WORK MEETING AGENDA OF THE CITY COUNCIL OF LAYTON, UTAH

Discussion - 2015 Revised Developmental Guidelines and Design Standards

2015 Changes to Standard Drawings:

STANDARD
DRAWING
1" METER
ST-WL-01

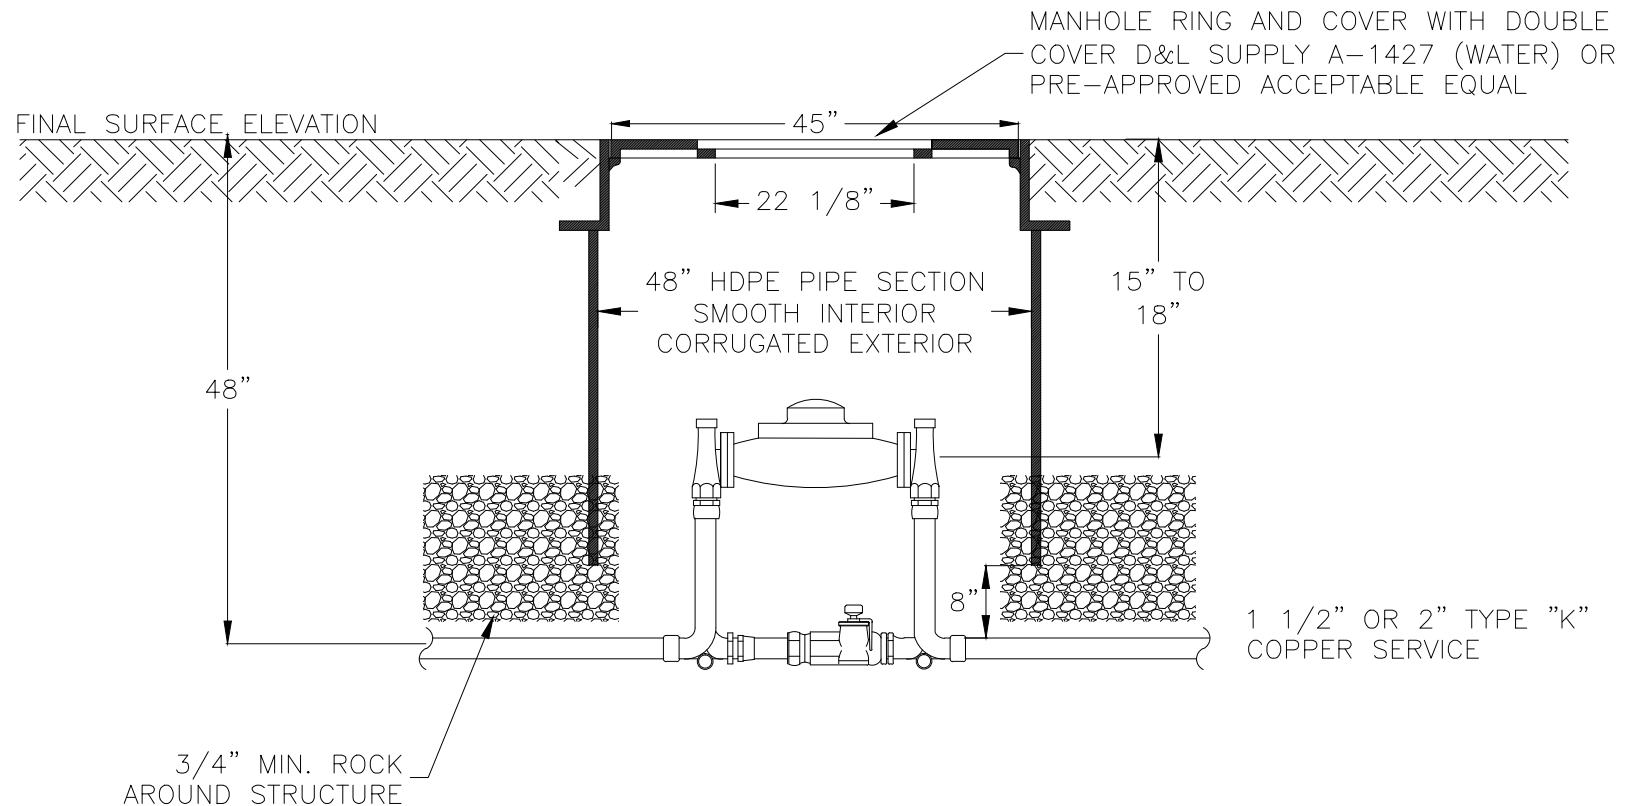
- i. ST-WL-01 – ¾" & 1" water service connection
 - 1. Added note for tracing wire to terminate in meter box
 - ii. ST-WL-03 – HDPE Meter Box for 1 ½" or 2" water service

DRAWN BY SWJ		STANDARD DRAWING
SCALE NONE		
DATE 5/14		OCTAVE METER NO REDUCER
REVISIONS 1/15		ST-WL-05

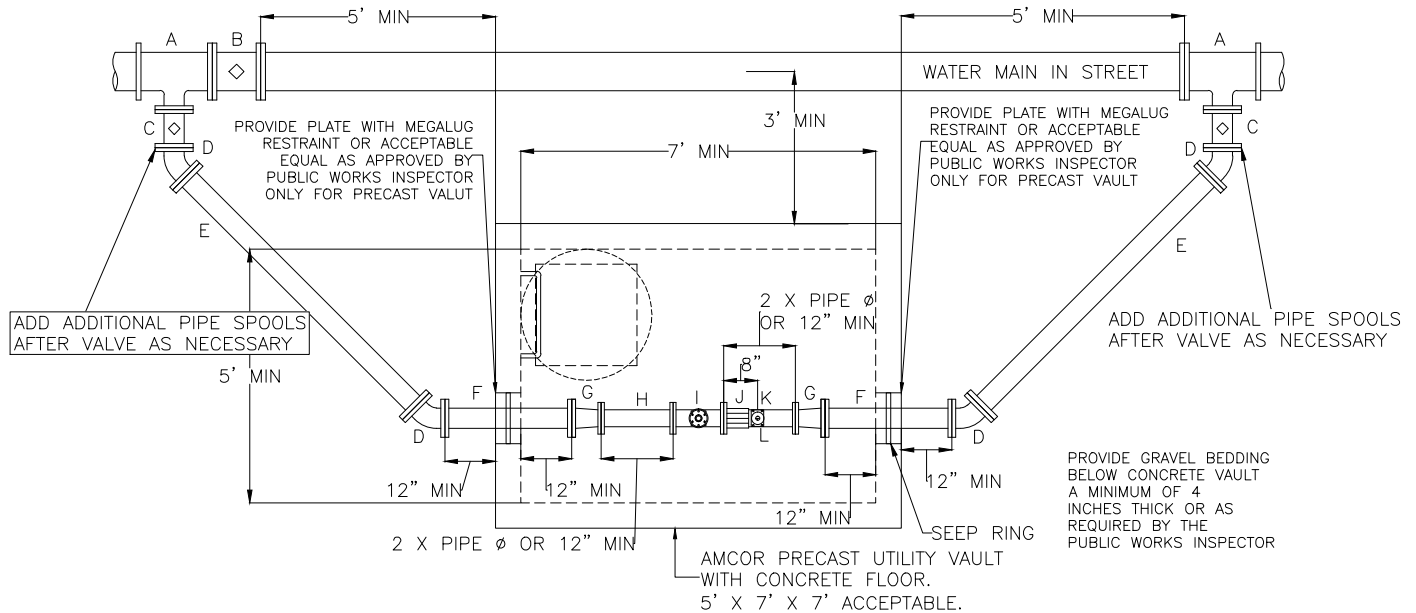
- a. New meter standard
 - i. ST-WL-05 – 4", 6", or 8" octave meter without reducer
 - ii. ST-WL-06 – 3" or 4" Octave meter with reducer
- b. Updated meter standard
